# Local Planning Panel

## 18 May 2022

108, 110, 112 Victoria Street, Beaconsfield

D/2021/1054

laneway structures' internal elevation

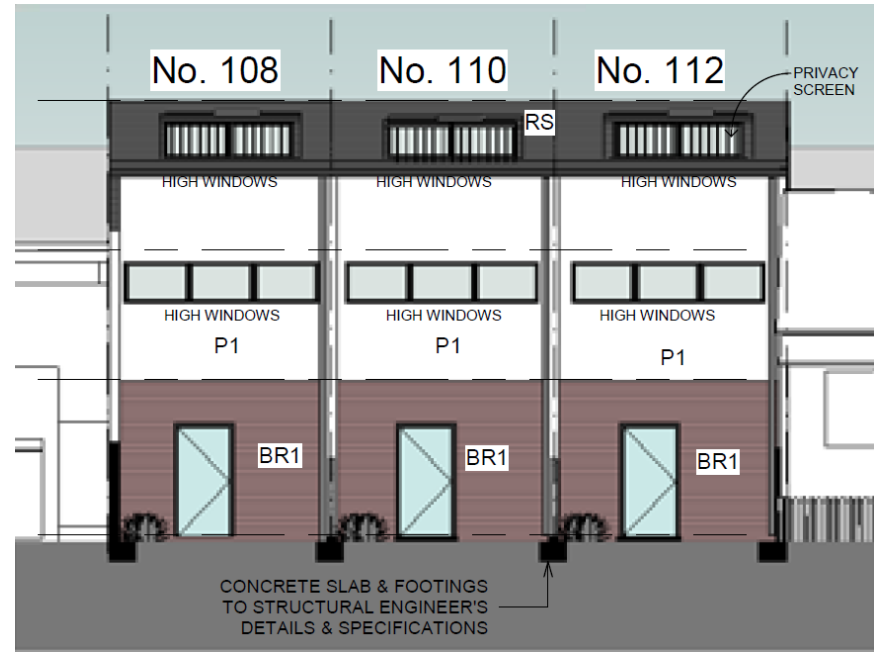
- condition recommended to modify the roof form
- enable lowering of sill heights to improve residential amenities
- reduce visual bulk from private open spaces

- condition to lower the sill height for studio windows from 1.8m to 1.4m
- made possible by modifications to the roof form
- improve solar access, ventilation, outlook

# building alignment

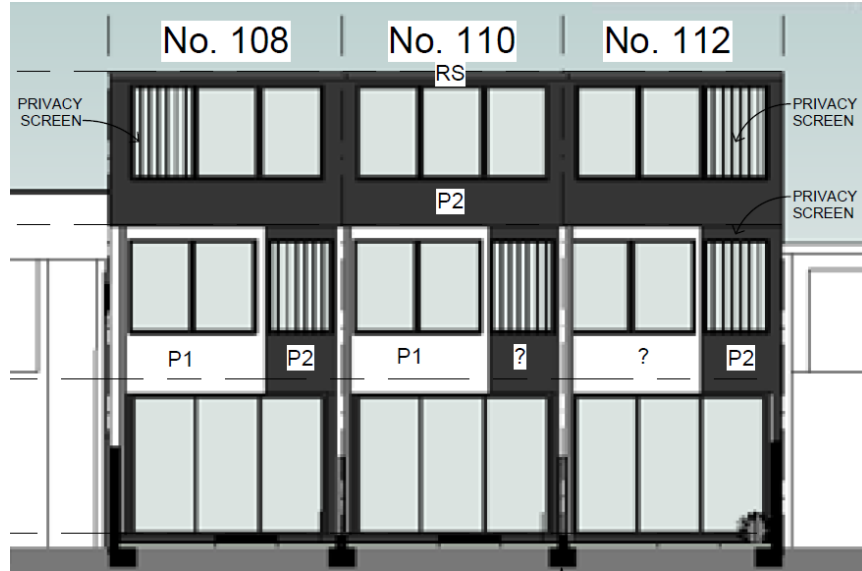
- verandah alignment (blue dotted line) acceptable
- front building line (blue solid line) – condition recommended to increase the front setback to be consistent with the predominant alignment established by 90-106 Victoria St
- rear first floor building line (red solid line) acceptable, considering:
  - consistent with other existing/approved developments
  - behind rear ground floor building line of adjoining 114-116 Victoria St to minimize visual bulk
- depth of laneway structure (green solid line) acceptable as consistent with other garages/laneway structures
